Engineering Land Use Application Comments

To: Joy Chang, Associate Planner
From: Bob Galati, P.E., Engineering Department
Project: Parkway Village South (SP17-01, SUB17-03)
Date: December 5, 2017

Subject: Parkway Village South 5-Lot Commercial Subdivision, SP 17-01 and SUB 17-03, 2S129DC00900, 01000

Date: November 27, 2017
Project: Parkway Village South (SP17-01, SUB17-03)
To: Joy Chang, Associate Planner
From: Bob Galati, City Engineer
Topic: Response to Applicant Comments on Conditions of Approval.

AKS DRAWING FILE: 5656 P09 PRELIMINARY COMPOSITE UTILITY PLANNING LAYOUT: P09

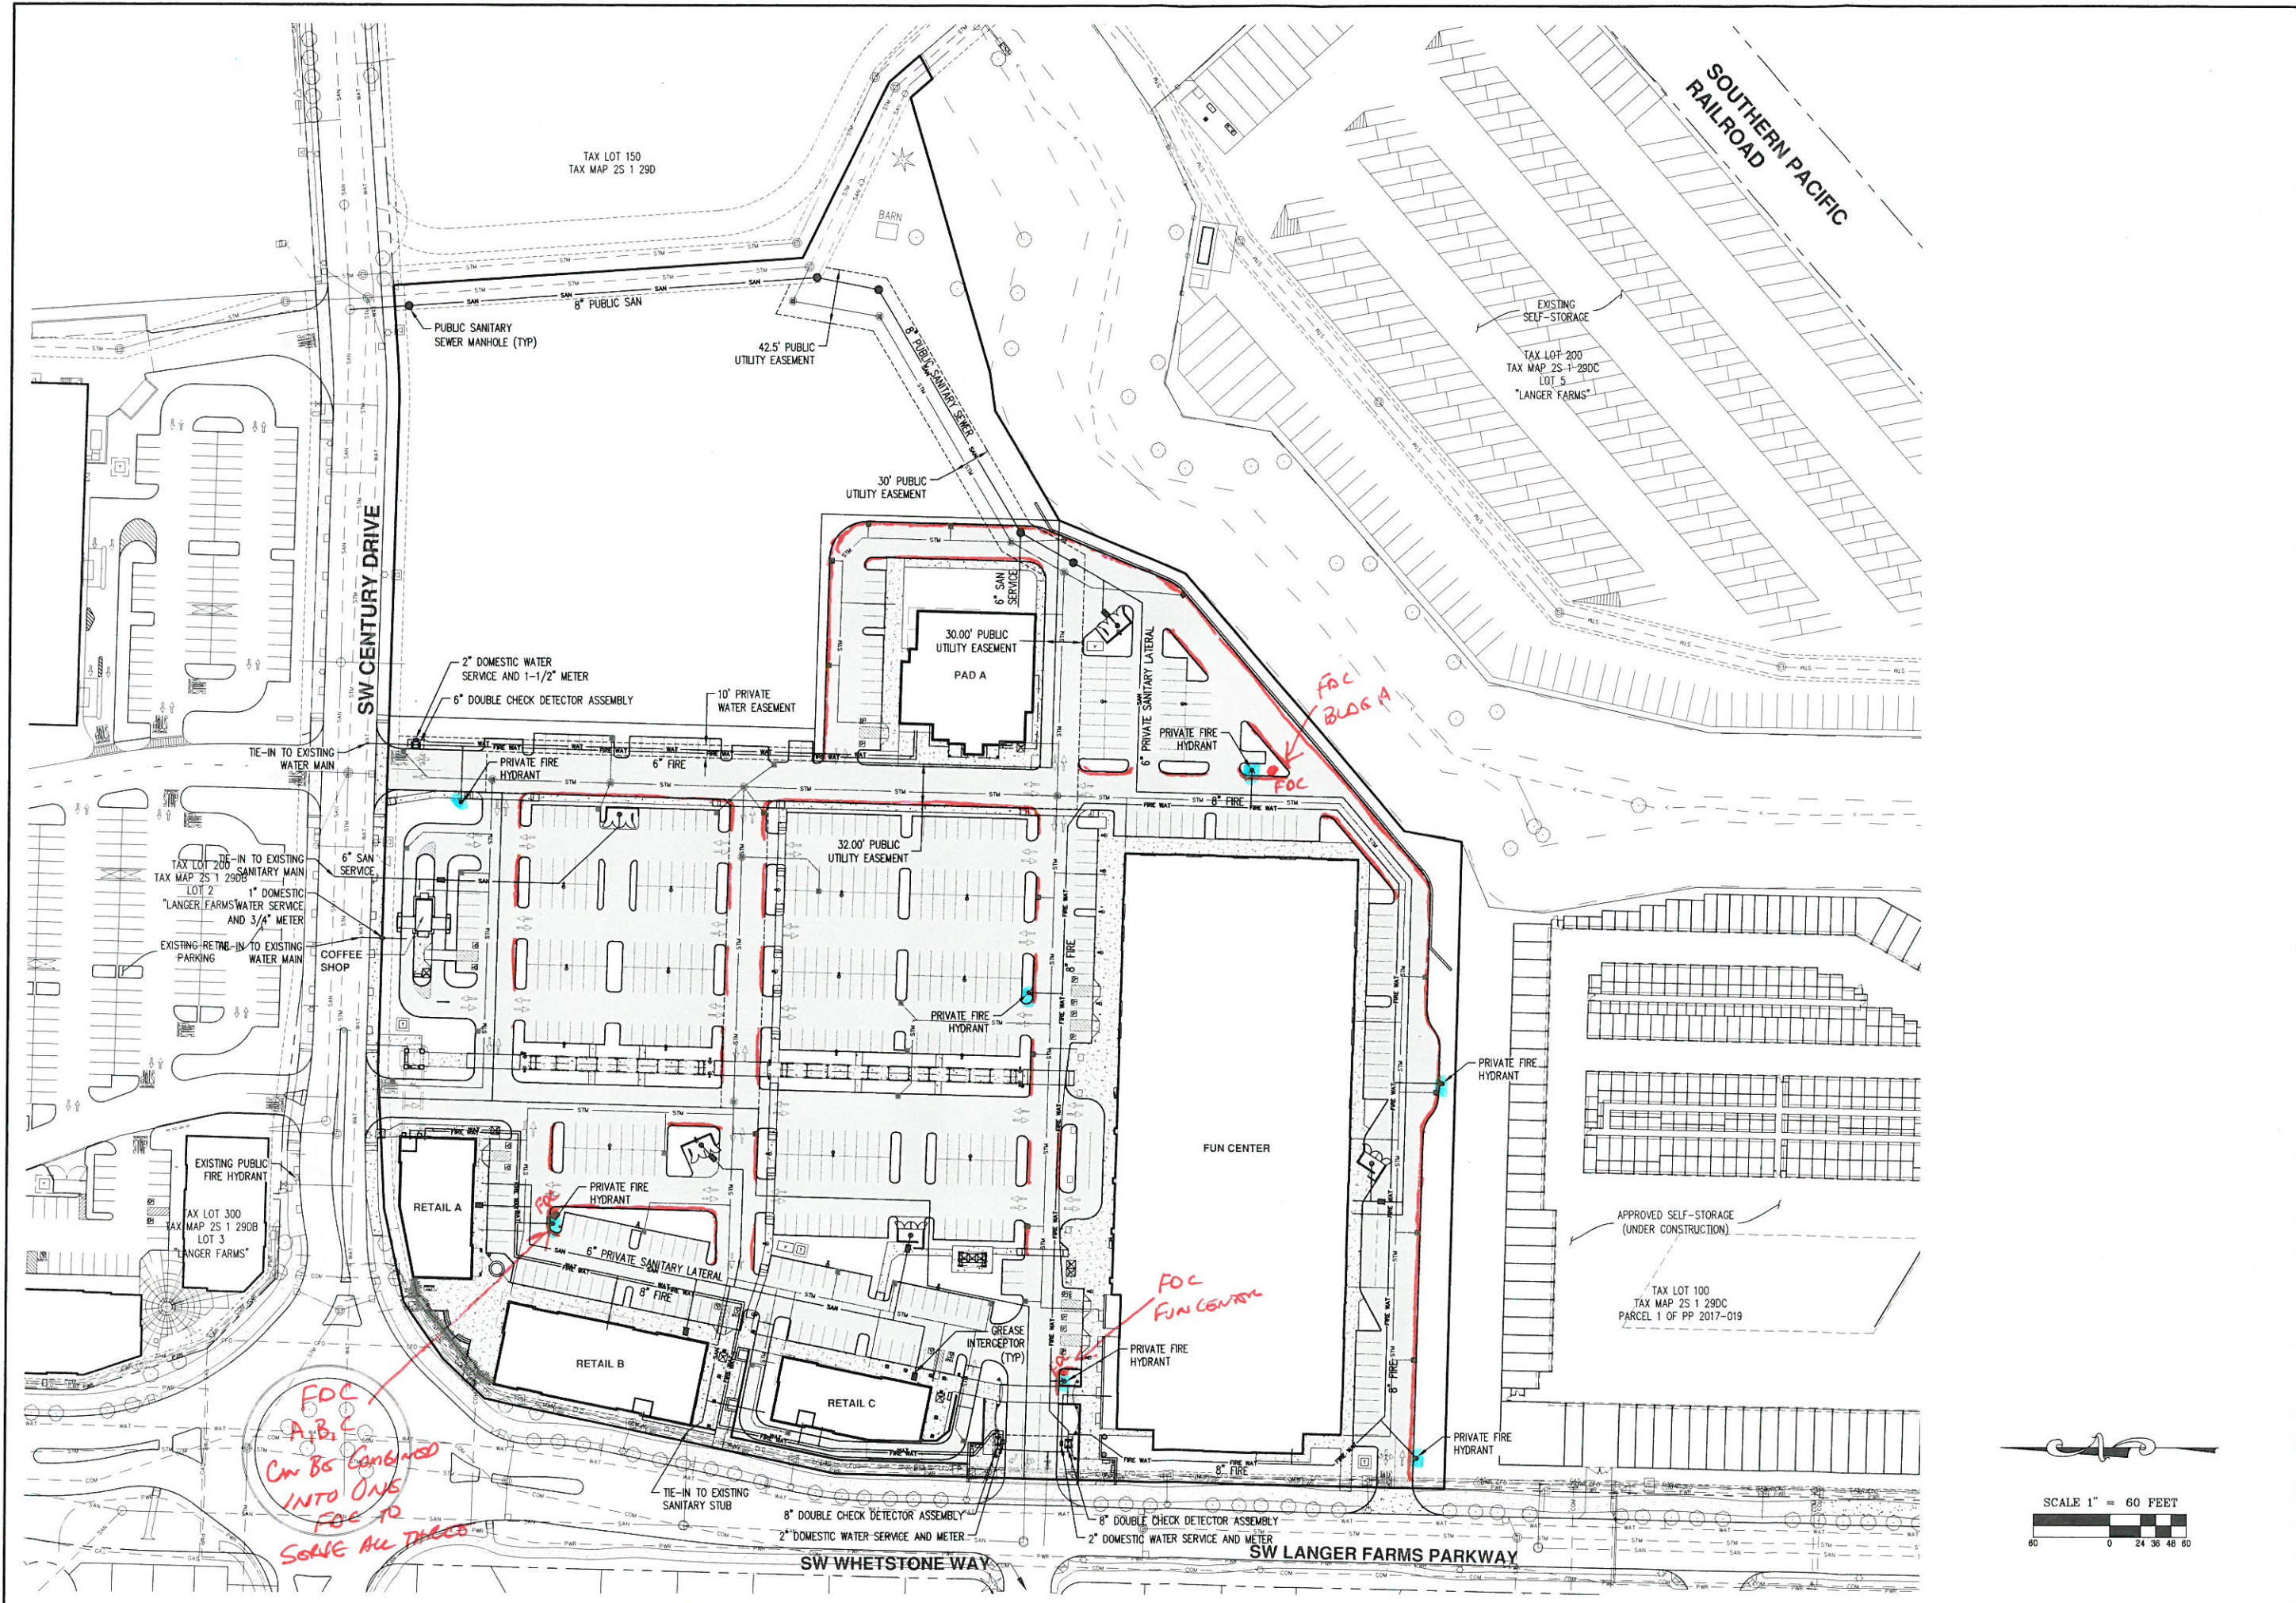
See attached sheet P09 for locations of fire lanes.

Plans indicate private hydrants. Private hydrants shall be painted red in color.

See attached sheet P09 for locations for FDC's.

SP
1.1

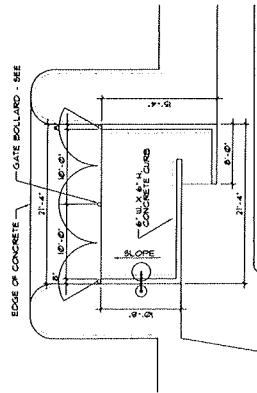
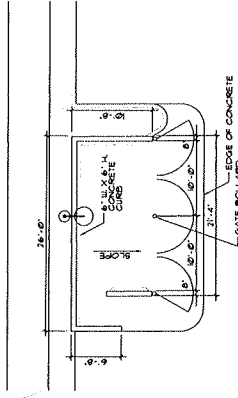
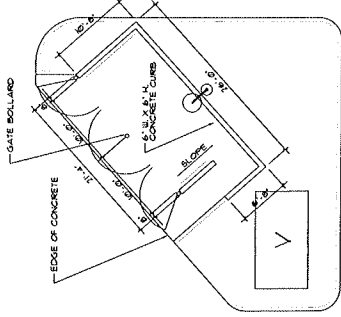
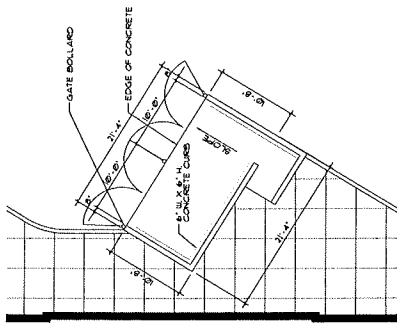
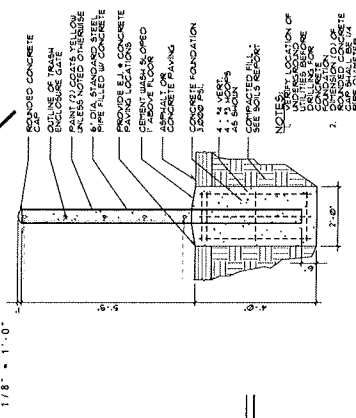
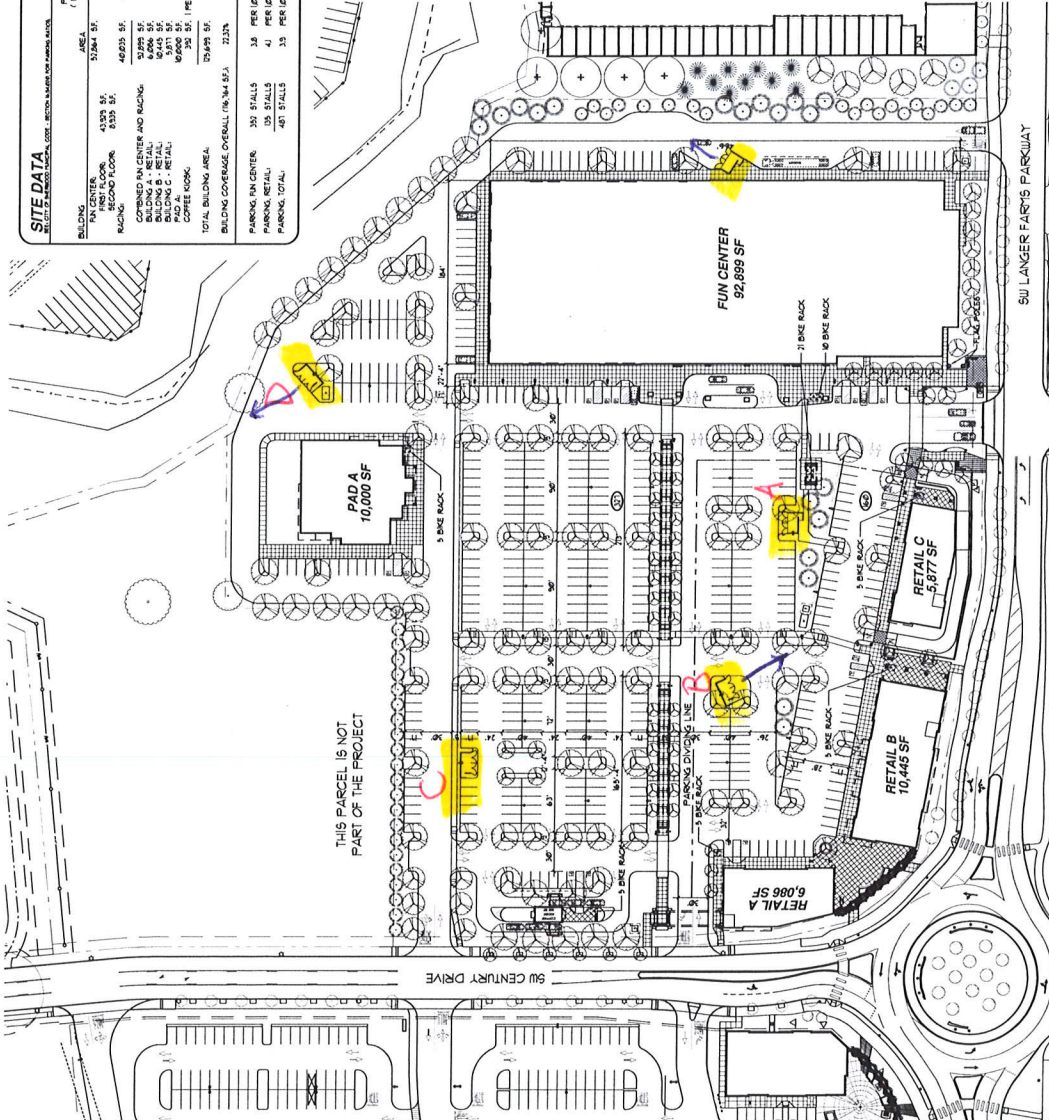
We have reviewed the site plan for the above-mentioned project. The site plan shows 5 enclosures on the property all meeting the required 10' deep by 20' wide, all allowing straight on access.

The other details on the site plan are not shown. These requirements will need to be met to ensure our access:
